**Re: Request for Further Information – 57-69 Strathallen Avenue, Northbridge**

Gyde Consulting represent SJD NB Pty Ltd, the applicant of the above Development Application (DA2024/106). Willoughby City Council issued a Request for Further Information (RFI) dated 26 September 2024.

## RFI Response

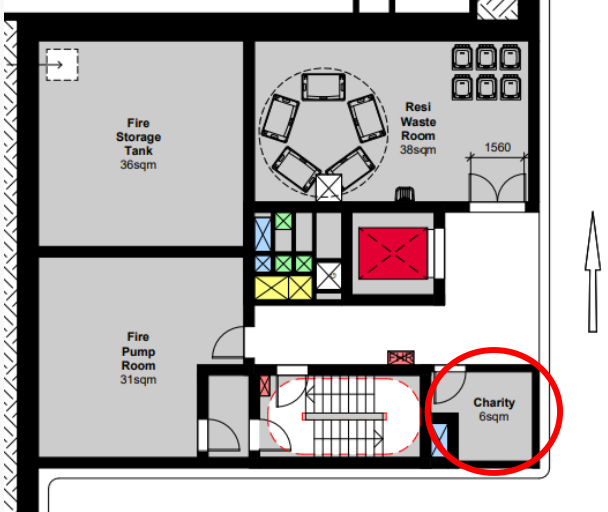
RFI Matter	Response
<p>The plans have not demonstrated that vehicle access and parking arrangements are suitable for the development and comply with the requirements of AS/NZS 2890.1. Items requiring amendment or further information are:</p>	<p>Refer to individual responses below. This section is to be read in conjunction with:</p> <ul style="list-style-type: none"> <li>• Traffic Response to Council's RFI Letter prepared by MLA Transport Planning.</li> <li>• Updated architectural plans prepared by Bates Smart.</li> </ul>
<p>The proposed single lane ramp between the ground floor and basement 1 is not acceptable and needs to be increased to 2-way traffic, due to the level of retail traffic, the proximity of the top of the ramp to the loading bay and the potential conflict and congestion created adjacent to the loading bay for vehicles waiting to access the single lane ramp.</p>	<p>As the retail tenancies are expected to draw their customs from walk in pedestrians and people using public transport, the retail car parking spaces are proposed for retail owners and staff.</p> <p>It is expected that traffic movements on the ramp to be minimal. The proposed development would generate up to 18 vehicles per hour (two-way traffic) during the busiest periods, which includes 13 vph rising from retail tenancies, which is a conservative estimate. The single lane ramp access complies with Australian Standard AS2890.1, which permits accesses with less than 30 movements per peak hour to be provided as a single lane.</p> <p>MLA have provided further detail in their Traffic Response to Council's RFI Letter in which they conclude in their assessment that:</p> <p><i>"the proposed single lane ramp between the ground floor and Basement 01, is therefore, considered to be satisfactory".</i></p>

<p>As retail spaces will not be all day parking but will include medium term parking catering for visitors to the retail areas, spaces for the retail area must comply with the requirements of AS/NZS 2890.1 for Class 2 medium term parking spaces.</p>	<p>Retail car parking spaces will be allocated to retail owners/tenants and retail staff. Retail uses will be occupied by smaller local businesses that serve the local community, that draw their custom from walk in pedestrians and people using public transport. The car parking spaces will operate as Class 1A long term car parking spaces under AS/NSZ 2890.1. This requires retail car parking spaces to have a dimension of 2.4m wide by 5.4m long. This has been updated on the architectural plans, see extract below, refer to Dwg. No. A03.001 prepared by Bates Smart.</p> 
<p>Typical dimensions are to be provided for parking spaces, to confirm widths comply with the requirements of AS/NZS 2890.1 and AS 2890.6.</p>	<p>Dimensions are provided for car parking spaces. Refer above regarding retail car parking spaces. Residential car parking space dimensions have also been provided. See extract below, refer to Dwg. No. A03.002 prepared by Bates Smart.</p>

RFI Matter	Response
	 <p>MLA confirm that the car parking spaces are of the following dimensions, which comply with AS2890.1, AS2890.6, and Willoughby DCP requirements.</p> <ul style="list-style-type: none"> <li>• residential spaces – 2.4m wide by 5.4m long</li> <li>• accessible dedicated spaces and shared areas – 2.4m wide by 5.4m long</li> <li>• retail staff spaces – 2.4m wide by 5.4m wide long, and</li> <li>• residential visitor spaces – 2.5m wide by 5.4m wide long</li> </ul> <p>Refer to the Traffic Response to Council's RFI Letter prepared by MLA.</p>
<p>Both basement parking levels include visitor parking and have dead end / blind aisles with no ability for a visitor to turn around in the event that parking is not available. Details of proposed turn around areas are to be provided to cater for visitors unable to find parking on each level.</p>	<p>It is proposed to include a warning sign at the car park entrance from the street near the proposed intercom that reads 'Visitor parking full when lights are on' or wording to that effect.</p> <p>This will be activated by vehicle presence sensors installed in the visitor parking spaces.</p> <p>This will notify visitors not to enter the carpark when full and will avoid visitors having to turn around the car park if parking is not available.</p> <p>As the visitor car parking proposed is compliant with the DCP requirements, it is not anticipated that visitor car parking will not be available when required.</p> <p>Refer to the Transport Response to Council's RFI Letter prepared by MLA for further detail.</p> <p>The applicant accepts that a condition may be prescribed that requires installation of appropriate signage as detailed above prior to issue of an occupation certificate.</p>

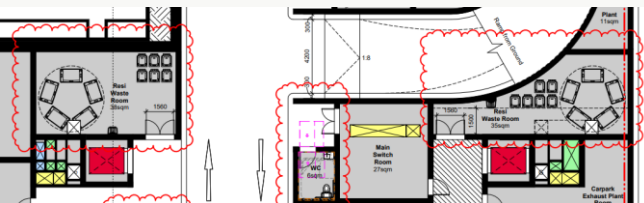
<p>The wall at the top of the ramp inhibits the view to the loading bay and the driveway for vehicles leaving the basement. As this is the main traffic route for vehicles leaving the site, reducing the height of the wall or cutting the wall back is required to increase visibility and improve safety and minimise vehicle conflict.</p>	<p>The potential to reduce the height of the wall or cutting the wall back was assessed by Bates Smart and MLA following receipt of the RFI from Council. Numerous options were considered and from a design perspective, ultimately the design of the wall at the top of the ramp is crucial to the integrity of the development's design.</p> <p>The wall defines the planter's edge of the apartment level above and minimises the vertical clearance required for the loading dock entry. It also mitigates the visual impact of this façade of what would be an otherwise large and obtrusive opening. Reducing the height of the wall or cutting it back would result in a less favourable design and impact of the proposed development to the eastern façade where it adjoins the low density residential area.</p>

RFI Matter	Response
	<p>MLA confirm from a traffic safety perspective that the wall is not expected to pose any visibility or safety issues. Management of traffic movements will be controlled by a traffic light system to manage vehicle movements using the ramp and the loading dock.</p> <p>The applicant accepts that a condition may be prescribed that requires the installation of a traffic mirror opposite the wall to increase visibility and improve safety.</p>
<p>Swept path diagrams provided do not clearly show the extent of the vehicle crossing and the location of the building structure is not clear on all diagrams. Revised diagrams are to be provided that clearly show the vehicle crossing, the edge of the frontage road and the outline of the building structure, to allow confirmation that the space provided is suitable. Diagrams are to be provided for the following situations:</p> <ul style="list-style-type: none"> <li>• Council's 10.5m waste vehicle between the frontage road and the loading bay, both entry and exit.</li> <li>• Simultaneous movement of an SRV and a B99 vehicle between the frontage road and the loading bay, excluding the reversing movement into or out of the loading bay.</li> <li>• Simultaneous movement of a B99 and B85 vehicle between the frontage road and the base of the ramp down from ground level at Basement 01.</li> </ul>	<p>Additional swept path diagrams have been prepared by MLA. Refer to Attachment 1 to the Traffic Response to Council's RFI Letter.</p> <p>Attachment 1 includes the following swept path diagrams to respond to Council's request:</p> <ul style="list-style-type: none"> <li>• Dwg. No. 23044CAD007A-001 – Swept Path Analysis – 10.6m waste vehicle entering and exiting – ground floor.</li> <li>• Dwg. No. 23044CAD007A-002 – Swept Path Analysis – AS2890.2 6.4m SRV entering vs. AS2890.1 B99 vehicle exiting – ground floor.</li> <li>• Dwg. No. 23044CAD007A -003 – Swept Path Analysis – AS2890.1 B99 vehicle entering vs. AS2890.1 B85 vehicle exiting – ground floor.</li> </ul>

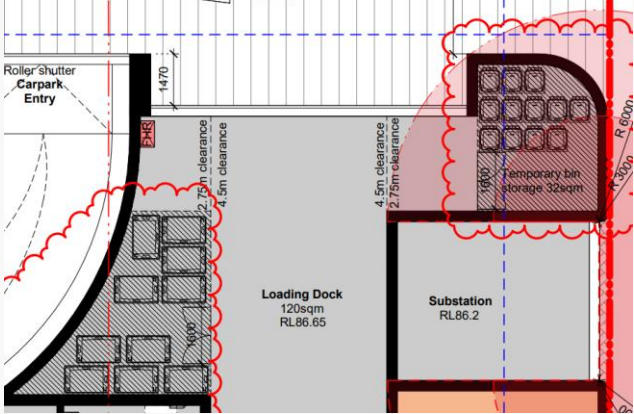
<p>A roller door is proposed at the top of the ramp leading down to the residential parking. Details are to be provided to demonstrate how access will be provided for visitors to gain access to the visitor parking in Basement 02.</p> <p>Revised plans are to be submitted to address the items raised above.</p>	<p>A roller door is proposed to the carpark entrance to ensure safety for access to residents and visitors of residents. A waiting bay with an intercom has been included to allow visitors to residents to call the resident to be gained access virtually from the individual apartment. See extract below, refer to Figure 2 in the Traffic Response to Council's RFI Letter prepared by MLA.</p>

RFI Matter	Response
	<p>A swept path analysis for this additional movement and waiting bay to be included beside the intercom has been prepared by MLA Transport Planning. See extract below, refer to Dwg. No. 23044CAD007A-004 prepared by MLA.</p>  <p>The drawing shows a site plan with a proposed intercom for residential visitors. A red line indicates the swept path of a vehicle. A legend on the right lists dimensions: 1000mm, 1500mm, 2000mm, 2500mm, 3000mm, 3500mm, 4000mm, 4500mm, 5000mm, 5500mm, 6000mm, 6500mm, 7000mm, 7500mm, 8000mm, 8500mm, 9000mm, 9500mm, 10000mm. A table on the right provides drawing details: DATE: 18 OCTOBER 2024, SCALE: 1:200@A3, DRAWING NO: 23044CAD007A-004, REV: A, DRAWING TITLE: SWEEP PATH ANALYSIS - AS2890 1.5.2M B99 VEHICLE ACCESSING INTERCOM -</p>
<p>Documents submitted detail that a Sydney Water sewer main is located within the site, which will required diversion, so that it is clear of the basement. In order to confirm that the sewer main will not impact the proposed development, a concept plan is to be provided to detail the proposed diversion of the main. The plan is to be accompanied by advice from a Sydney Water accredited designer that the relocation complies with Sydney Water requirements. Architectural plans are also to be amended to show the location of the relocated main.</p>	<p>The applicant engaged a Sydney Water accredited Water Service Coordinator Qalchek to review the proposed development against the Sydney Water anticipated development requirements and provide a concept plan of how the proposed sewer can be deviated and achieved. Please refer to attached documents including the Feasibility Letter (dated 28 October 2024), Concept Plan, and Water Hydra System Plan prepared by Qalchek.</p> <p>Details have also been updated accordingly on the architectural plans prepared by Bates Smart. See extract below, refer to Dwg. No. A03.100.</p>  <p>The drawing shows a cross-section of the ground level and a car park intercom. A red line indicates the proposed sewer. A legend on the right lists dimensions: 1000mm, 1500mm, 2000mm, 2500mm, 3000mm, 3500mm, 4000mm, 4500mm, 5000mm, 5500mm, 6000mm, 6500mm, 7000mm, 7500mm, 8000mm, 8500mm, 9000mm, 9500mm, 10000mm. A table on the right provides drawing details: DATE: 18 OCTOBER 2024, SCALE: 1:200@A3, DRAWING NO: 23044CAD007A-004, REV: A, DRAWING TITLE: SWEEP PATH ANALYSIS - AS2890 1.5.2M B99 VEHICLE ACCESSING INTERCOM -</p>

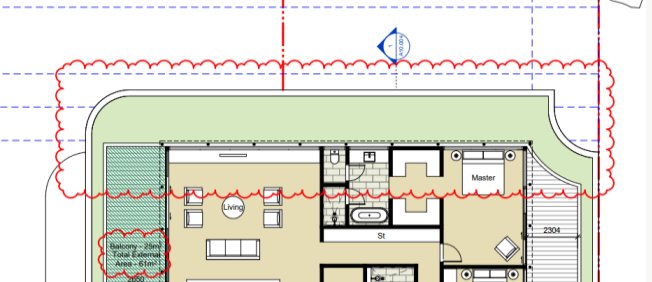
<ul style="list-style-type: none"> <li>• Recycling recovery: the inclusion of a waste cupboard for recycling disposal by residents</li> </ul>	<p>Recycling store cupboards have been provided on each residential level, see extract below, refer to Dwg.</p>

RFI Matter	Response
<p>is acknowledged. Please provide further detail on how this is to be serviced. Caretakers could service the 240L MBGs frequently, and decant the material in the basement into larger bulk bins which are presented for collection. This would ensure that residents will have access to recycling disposal during servicing periods as the MBGs would not be presented for collection.</p>	<p>No. A03.101 prepared by Bates Smart. These recycling cupboards are separate to the waste disposal chute cupboards.</p>  <p>It is proposed for residents to dispose of recycling waste in the waste cupboard at their level on each floor. A dedicated cleaner/caretaker will transport these 240L MBGs every second day to the larger 660L MBGs in the residential waste rooms at basement level 01. Further details are provided in the OWMP prepared by Eccell.</p>
<ul style="list-style-type: none"> <li>Waste chute equipment: please provide further information on the waste chute and any additional equipment that may be required. For example <ul style="list-style-type: none"> <li>Three-days of waste generation is required under the chute; to achieve this, other developments may use equipment like a linear track system or carousel.</li> <li>Please consider the space that any equipment would use and show there is still enough space to store the required number of bins, including any service bins that may be required during the collection period.</li> </ul> </li> </ul>	<p>A carousel system has been proposed to ensure that frequent and proper disposal of waste from residential waste chutes can be actioned. Consideration of these waste calculations has been outlined by Eccell in the waste estimate Table 5 in the OWMP.</p> <p>Appendix J outlines the proposed carousel system for 660L waste bins.</p> <p>The architectural plans have been updated by Bates Smart to identify the carousel system proposed and the space the equipment requires for operation (as advised by Eccell). See extract below, refer to Dwg. No. A03.001 prepared by Bates Smart.</p>

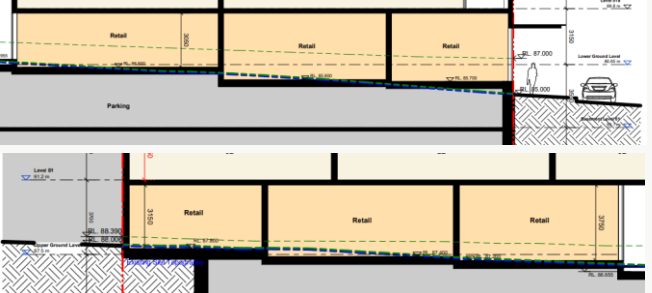
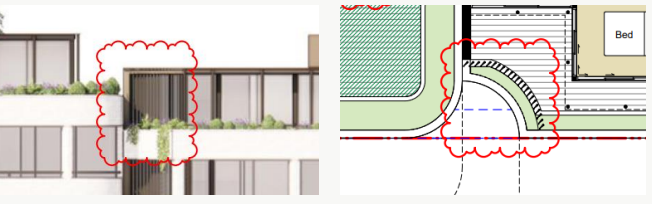
<ul style="list-style-type: none"> <li>Temporary bin storage area: please indicate the size available for bin presentation and bulky waste presentation on the architectural plans. Please also confirm how this area will remain available for waste bin presentation and bulky waste presentation and how the development will ensure bins are contained. Note: the development is able to propose a waste storage room that acts as the collection point and storage</li> </ul>	<p>Details of the temporary bin storage area has been updated to provide the information requested by Council. The sizes of these rooms required has been advised by Eccell.</p> <p>Temporary bin storage areas at ground level will be accessible by the dedicated caretaker/cleaner only and will not be accessible by residents. These temporary waste areas have been positioned away from habitable rooms, in an accessible location so that collection vehicles can service the development with minimal reversing, and positioned so that appropriate</p>

RFI Matter	Response
<p>point (if space and configuration allows) on the ground floor.</p>	<p>clearances are allowed for the collection vehicles can enter the premises, collect the waste and recycling, and exit the premises easily.</p> <p>See extract below, refer to Dwg. No. A03.100 prepared by Bates Smart for areas and details of temporary bin storage areas.</p> 
<ul style="list-style-type: none"> <li>Bin and bulky waste carting routes: the following details should be considered with respect to the current bin carting routes: <ul style="list-style-type: none"> <li>Please consider how bulky waste and bulk bins will be carted through the development to the presentation area (especially due to the typical size of residential bulky waste and potentially heavy bulk bins);</li> <li>Please detail any equipment that should be used by caretakers, such as bin tugs;</li> <li>The bin carting route should minimise gates, doors, steps and obstacles;</li> <li>Bins and bulky waste should not be carted through the residential lobby; and</li> <li>If bins and bulky waste has to be carted between different levels, a back-of-house lift should be provided.</li> </ul> </li> </ul>	<p>Due to the configuration of the proposed development and ground level uses, and the constraints of the site that limit the potential to provide a dedicated back-of-house lift, it is proposed to transport waste through the lifts which do also service the residential lobbies. This is a common practice across developments of similar size and scale, and cause no impact if the proper practices are in place</p> <p>Bin tugs will be used to transport 660L bins from the waste rooms to the lift, where they will be detached, taken up, and reattached to another bin tug to transport to the waste collection point.</p> <p>Transport of waste will be done so by a dedicated caretaker who will be provided with the appropriate PPE. Transportation of waste can be done so outside of peak hours of lift use by residents so as not to avoid obstruction or back up of the lifts for residents. The caretaker can also be advised to allow residents use of the lift first.</p> <p>Refer to the OWMP prepared by Eccell, and Appendix K which outlines the details of the bin tugs proposed to be used.</p>

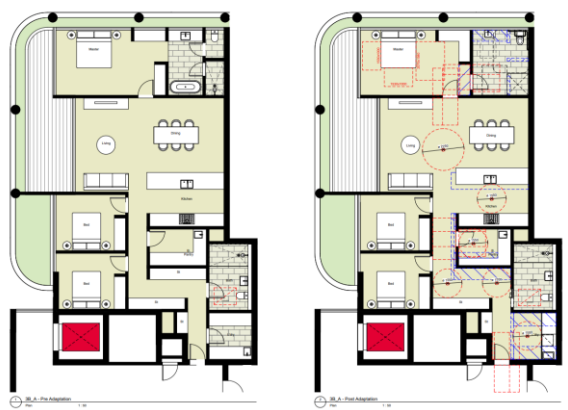
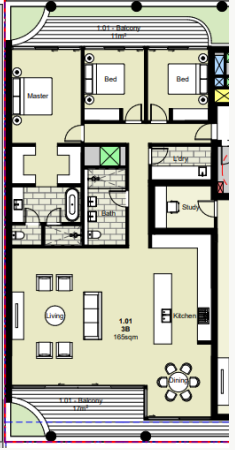
<ul style="list-style-type: none"> <li>Waste storage area amenities: please consider the following details that should be complied with: <ul style="list-style-type: none"> <li>Waste bin storage areas should have an aisle space of 1.5m;</li> <li>Doorways should be 2.5m wide;</li> <li>Floors should be reinforced concrete and 75mm thick; and</li> <li>Please indicate amenities (including door widths, taps and drainage) on the architectural plans.</li> </ul> </li> </ul>	<p>All waste bin storage areas have an aisle space of 1.5m and this has been clearly noted on the architectural plans prepared by Bates Smart. See extract below, refer to Dwg. No. A03.001 and A03.100 prepared by Bates Smart.</p>

RFI Matter	Response
	 <p>The 1.56m doorways proposed are consistent with aisle widths. Part 4.82(a) of the DCP outlines that “<i>all waste management facilities must comply with the Building Code of Australia and relevant Australian Standards</i>”. We note that the BCA requires doors to have a minimum clearance of 1.200mm (identified in Appendix L of the OWMP prepared by Eccell). This allows for the sufficient dimensions to transport the entry and exits of the waste bins proposed. Therefore, we comply with both the DCP and the BCA.</p> <p>Furthermore, bulky waste is also proposed at basement level 01 in a separate room with a proposed roller doorway of 2.5m, and therefore, only bins will be moving through the doors to the waste rooms with a 1.56m doorway.</p> <p>Floors of concrete construction are proposed, further details of which can be provided prior to the issue of a construction certificate.</p> <p>All amenities have been noted on the architectural plans prepared by Bates Smart.</p>

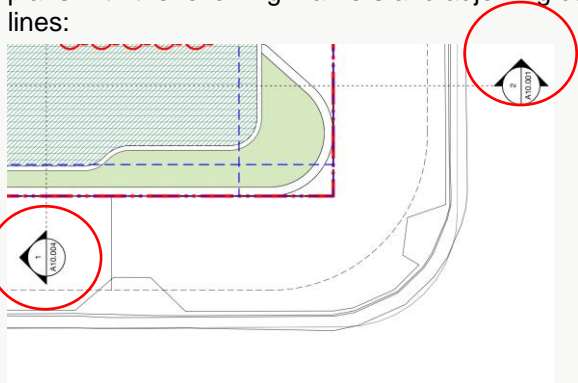
<ul style="list-style-type: none"> <li>Spacing behind bus stop</li> </ul> <p>The existing bus stop (ID 206352) on Strathallen Avenue should provide a minimum clearance of 1 metre, free from obstructions, to allow additional space for pedestrian movement.</p>	<p>The existing bus stop on Strathallen Avenue provides a minimum clearance of 1 metre, free from obstruction, to allow pedestrian movement between the bus stop and the proposed development. See extract below, refer to Dwg. No. A03.100 prepared by Bates Smart.</p>  <p>In order to provide a 1m clearance between the existing bus stop on Strathallen Avenue to the proposed development, the retail spaces at ground level have been slightly reduced and setback.</p> <p>This results in a reduction in total GFA from 5,116 sqm to 5,104 sqm.</p> <p>Due to the change in GFA, the Cl. 4.6 Variation Request for Cl. 4.4 Floor Space Ratio prepared by</p>

RFI Matter	Response
	<p>Gyde Consulting has been updated to reflect the change of the GFA, and therefore accurately reference the FSR that now applies.</p>
<ul style="list-style-type: none"> <li>Condition has been provided on top of standard conditions to request for a new pedestrian/ cyclist refuge and associated line marking and signage to be provided.</li> <li>Pedestrian and Bicycle Refuge (New) – Baringa Road and Strathallen Avenue intersection               <ul style="list-style-type: none"> <li>One 2.0 metre-wide minimum bicycle/ pedestrian refuge in Baringa Street at the intersection with Strathallen Avenue, east of Strathallen Avenue.</li> <li>All necessary line marking, pavement marking and signposting to support the new traffic and parking arrangements</li> </ul> </li> </ul>	<p>The applicant accepts that a condition may be prescribed that enforces the provision of a new pedestrian/cyclist refuge and associated line marking and signage to be provided to the Baringa Road and Strathallen Avenue intersection.</p>
